SECTION 00 90 10 ADDENDUM NO. 4

Project: Gallman Place Roof Renovation
Newberry, SC 29108
23234 – A

Date: 24 April 2026

T1.01

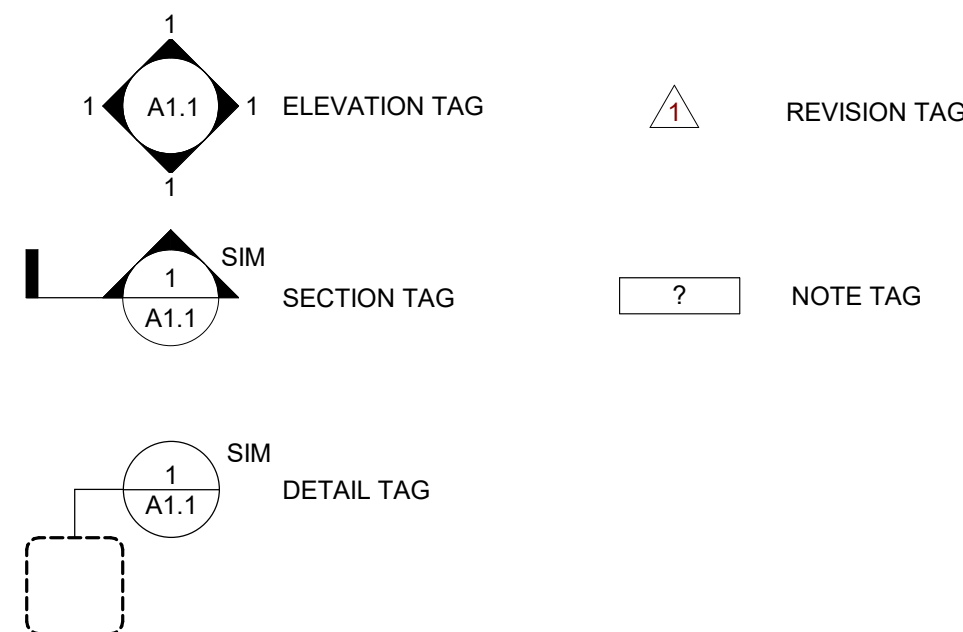
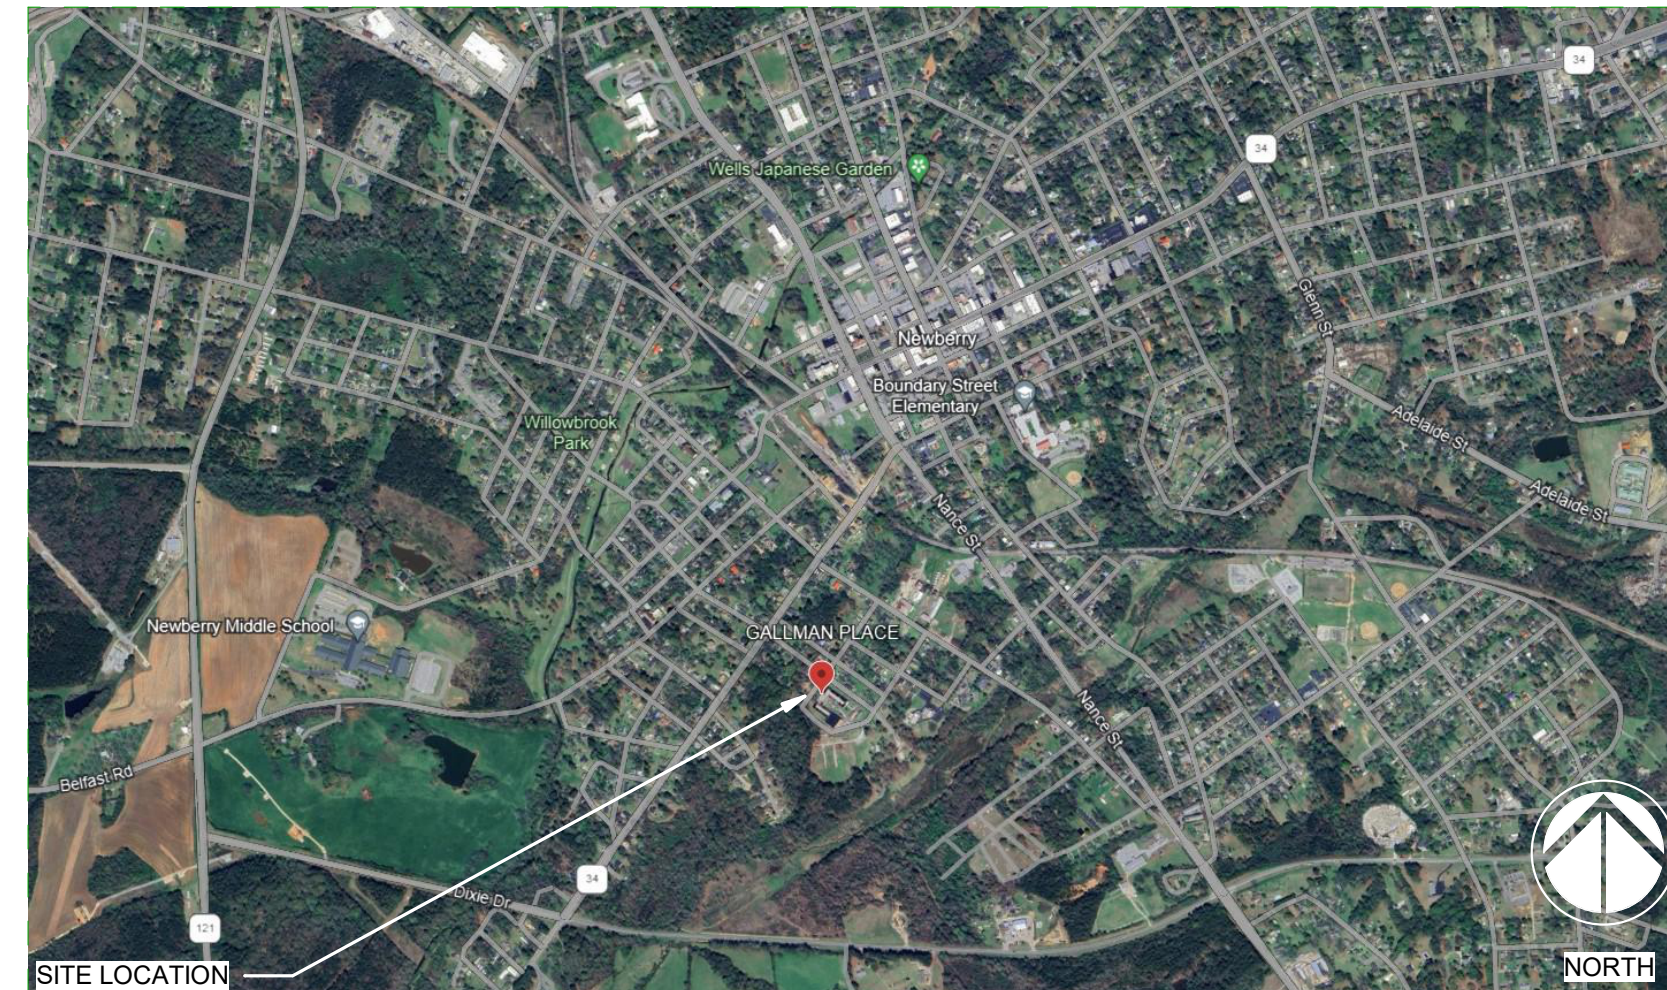
- T1.01 – TITLE SHEET – REV B
 - Added “Allowance No. 2: Include the sum of \$10,000 for miscellaneous repairs to the existing roof deck.”
